ADDENDUM

Five-Year Review Report

**Brookhaven National Laboratory Superfund Site
Town of Brookhaven, Hamlet of Upton
Suffolk County, New York**

This addendum has been prepared to address regulatory comments on the Five-Year Review Report for Brookhaven National Laboratory Superfund Site, Town of Brookhaven, Hamlet of Upton, Suffolk County, New York dated June 21, 2016.

Peconic Flow Data (2015)

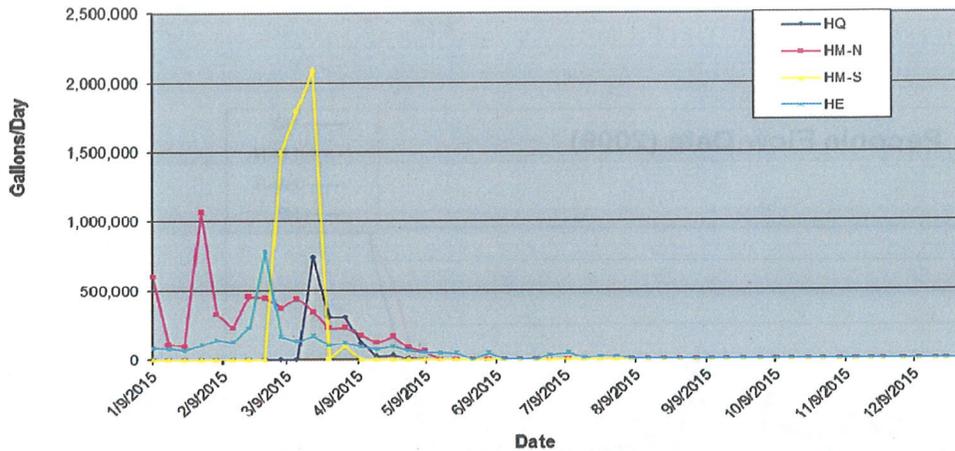
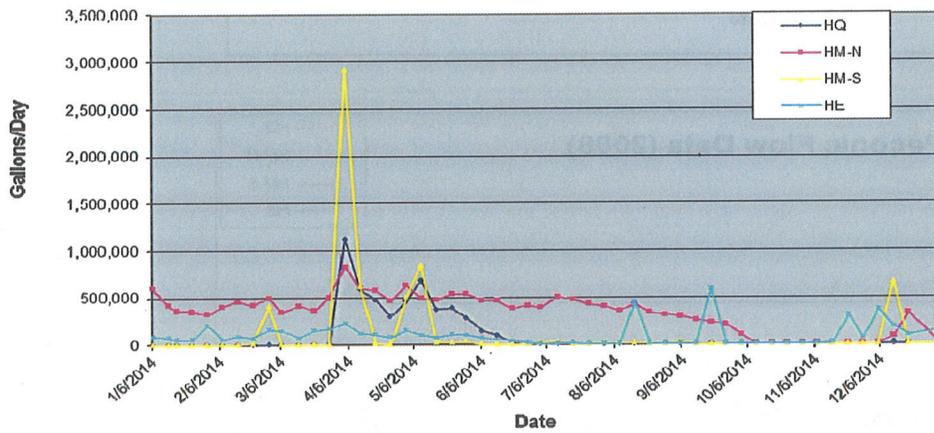
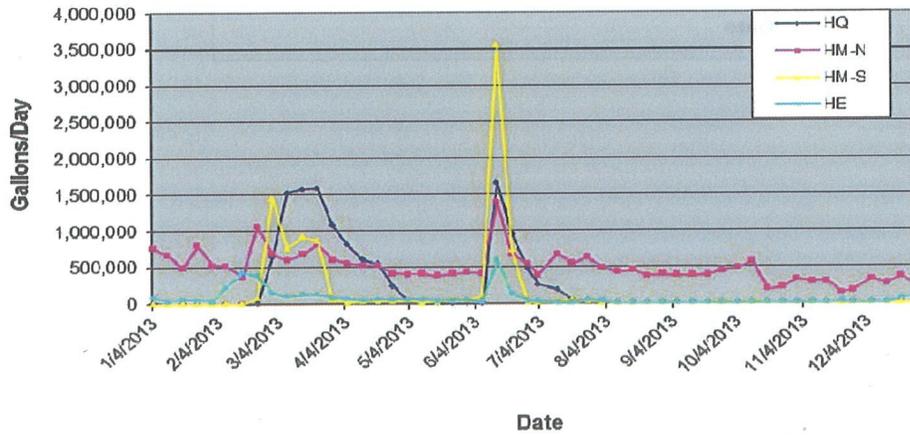
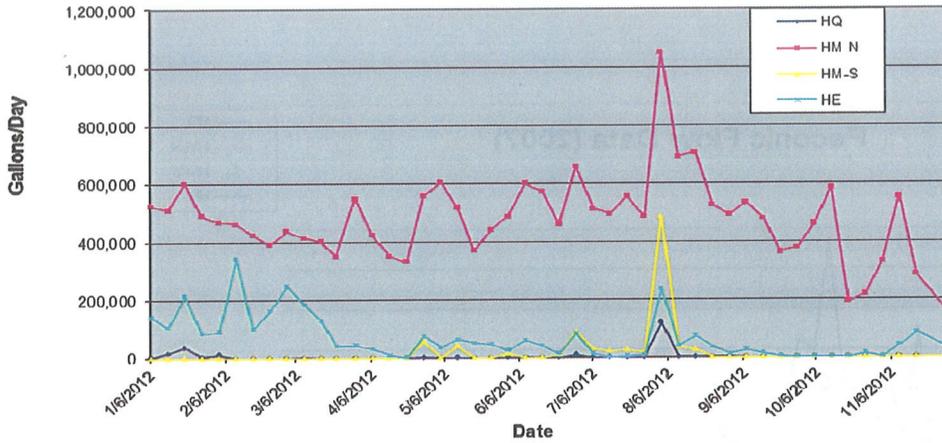
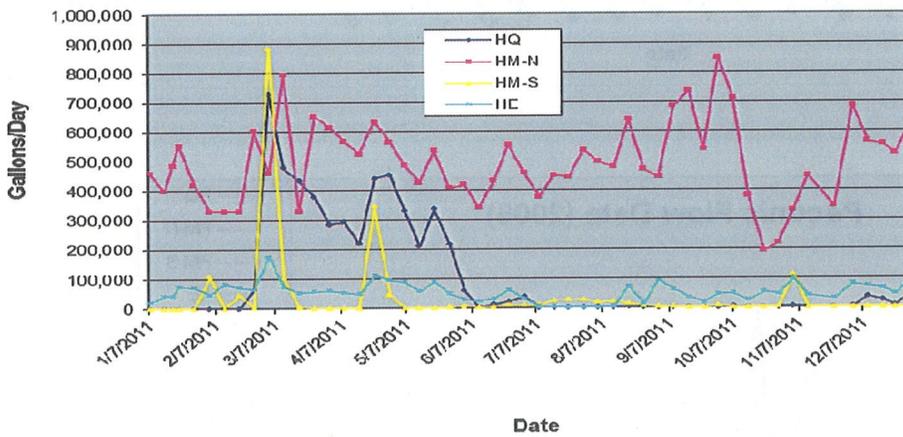
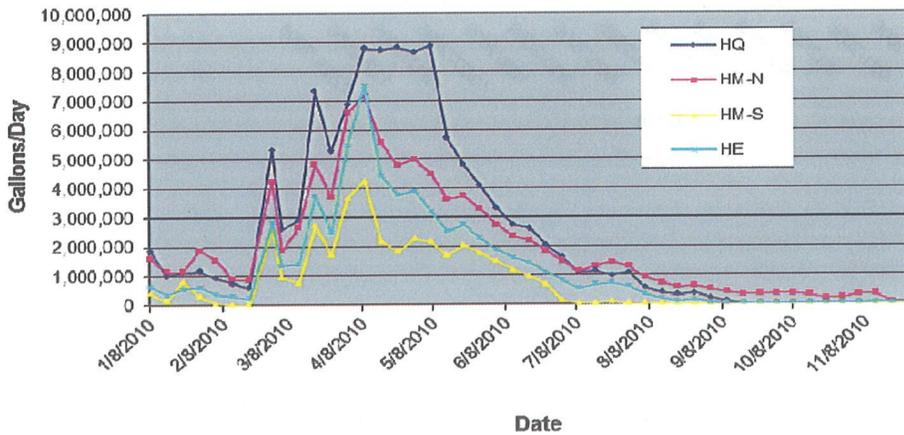
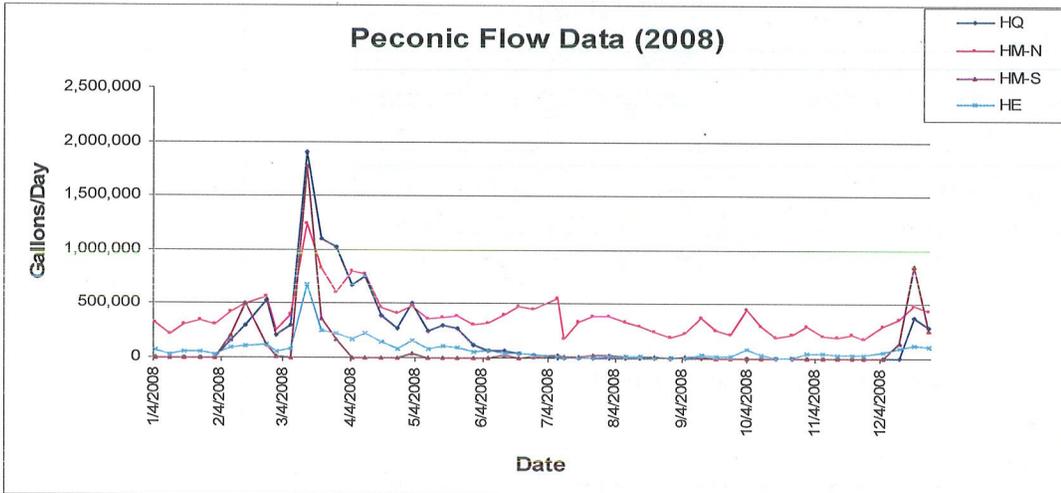
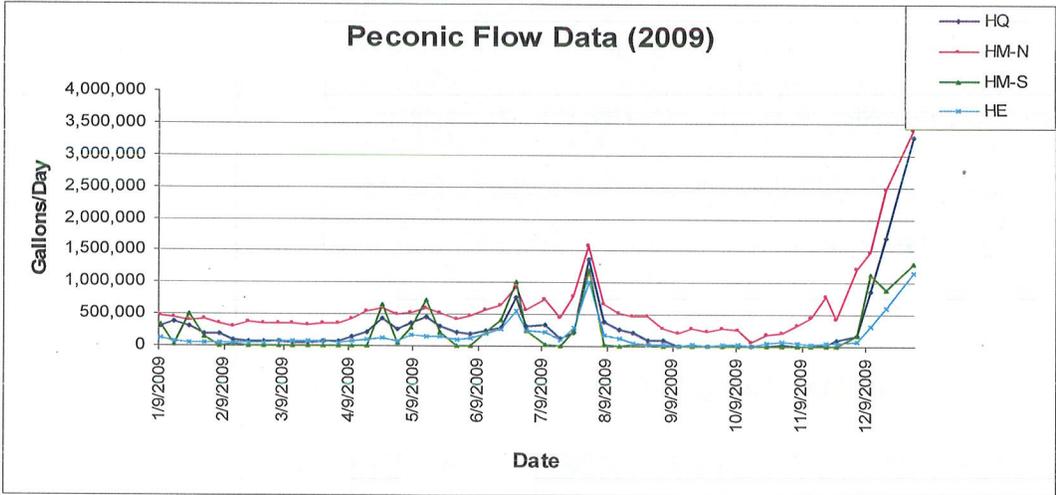
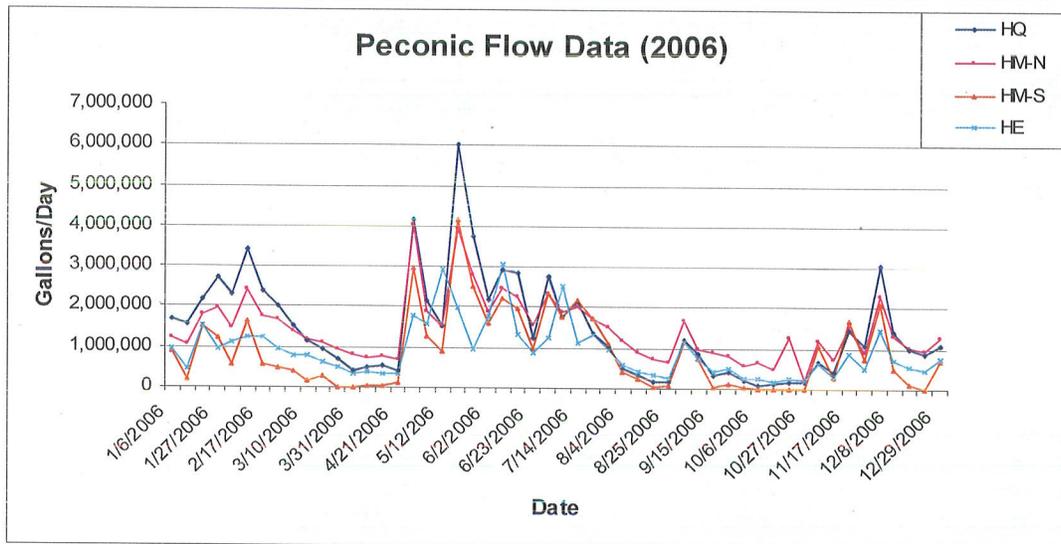
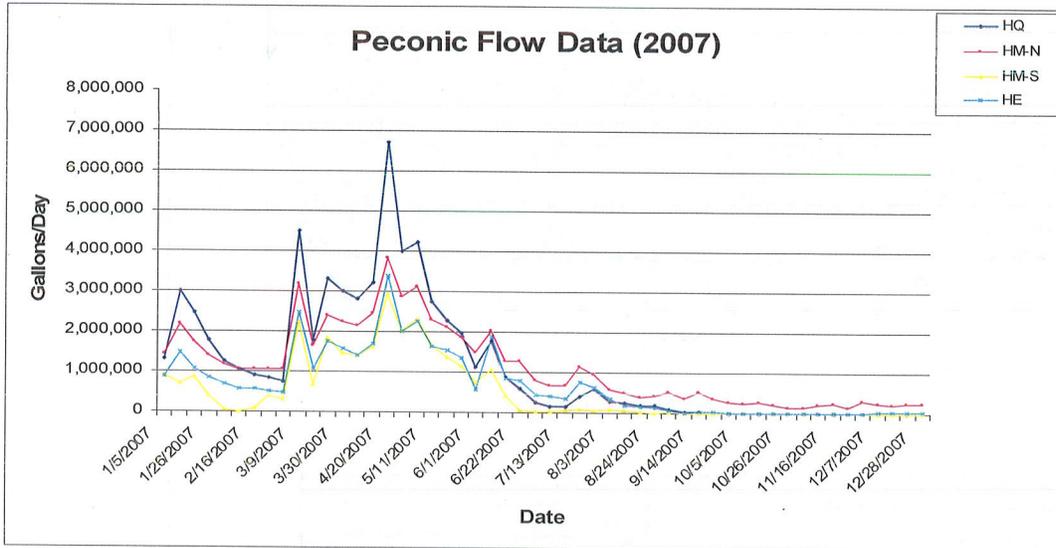
The Department considers the on-site portion of the Peconic River to be an intermittent river that is dependent on groundwater. The attached flow graphs show that water was present on-site for a portion of 2015, which is after the STP was shutdown in September 2014. Peconic Flow data for Station HE located near the STP indicated that flow occurred from January to May 2015. Peconic Flow data was available from the three stations, identified as HE, HM-N and HQ, from early March to mid April, which suggests that the fish were able to migrate within the on-site portion of the Peconic River. This is why in 2015 on-site fish were collected and sampled to determine mercury concentrations. Fish were collected from Areas A and C, which are upstream of Area D where the proposed cleanup will occur. The 2015 Site Environmental Report indicated that a small depression remained wet throughout the year as part of the Banded Sunfish assessment, which is considered a threatened species in the State of New York. The report further indicated that 2015 was a drought year. Based on this information the Department does not agree with the comments indicated by the EPA for the Five-Year Review Report. The Department finds that additional fish monitoring of the river is necessary to understand where fish are present throughout the year and future decisions should not be based on information obtained during drought conditions.

Based on your responses, the Department understands that the need to continue monitoring will be determined following the cleanup.

2009 to 2015 Mercury Concentrations in Peconic River Largemouth Bass

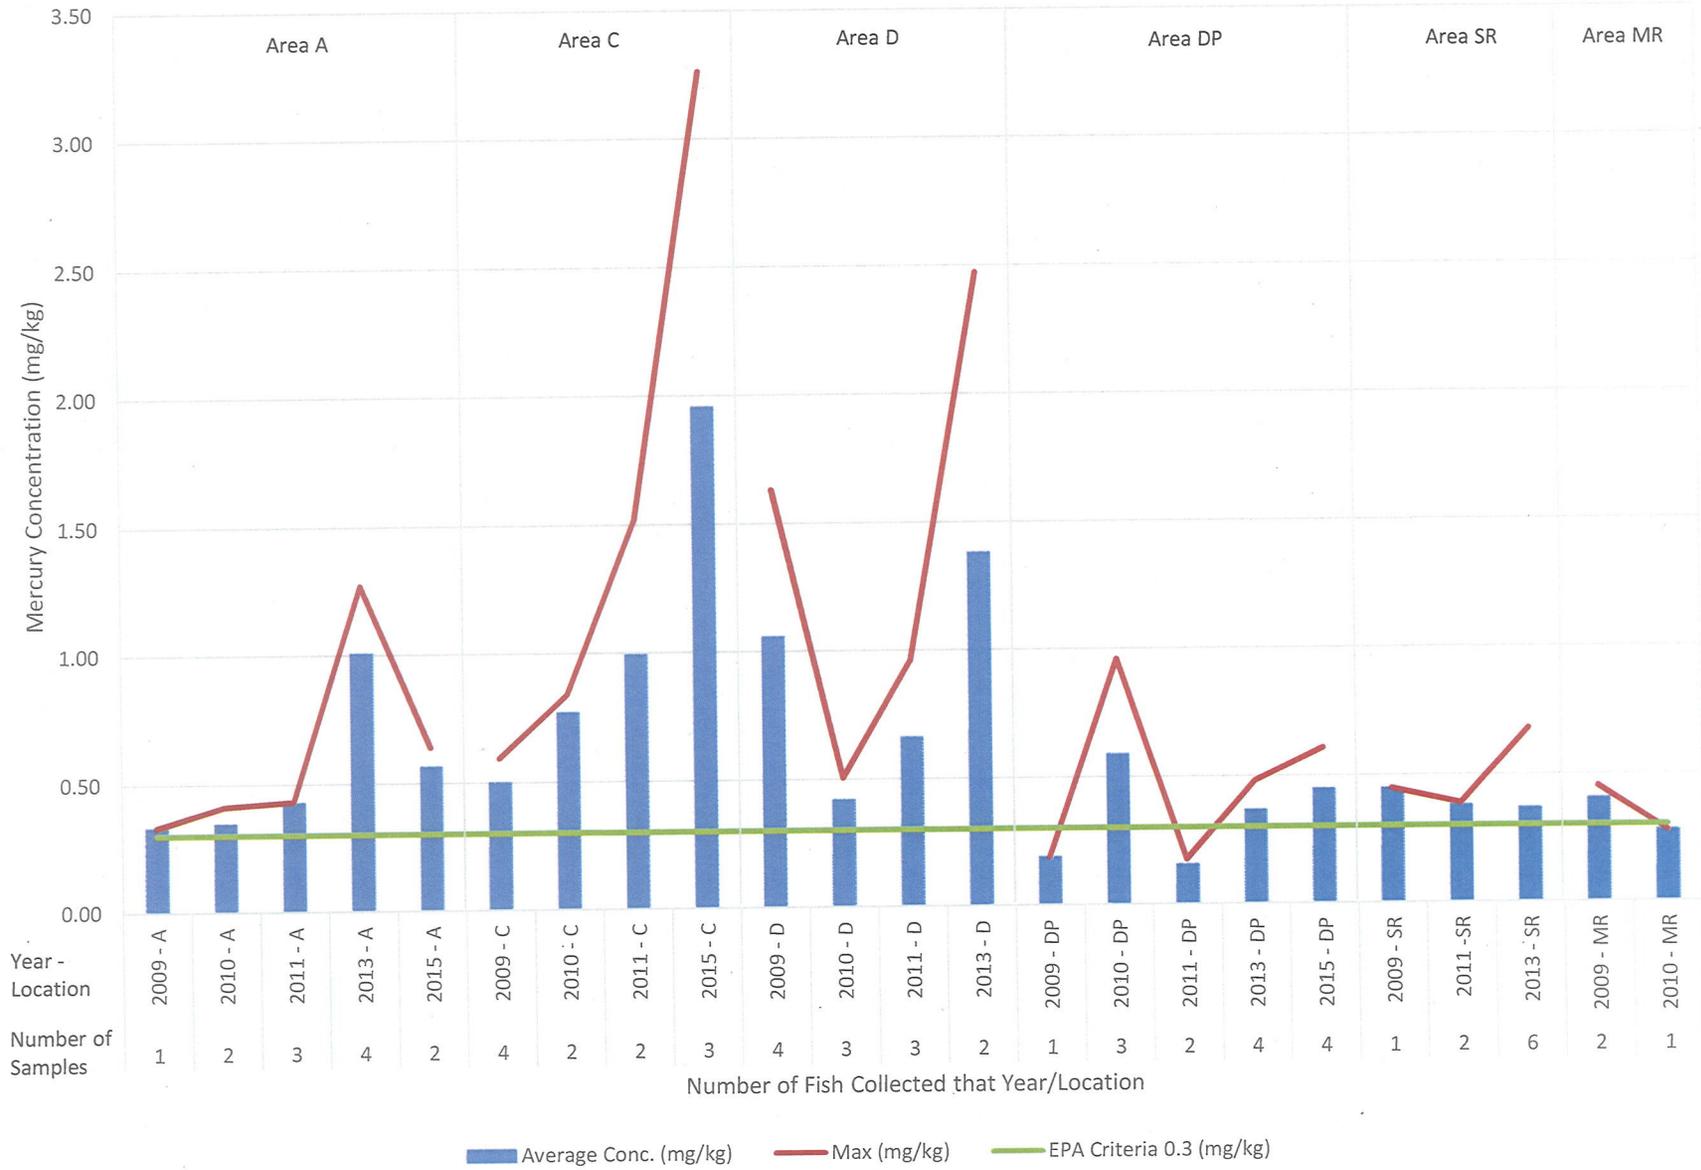
I have also included a graph of mercury results in Largemouth Bass from the Peconic River. Please note that the average mercury concentrations in the on-site fish are consistently above the EPA criteria.
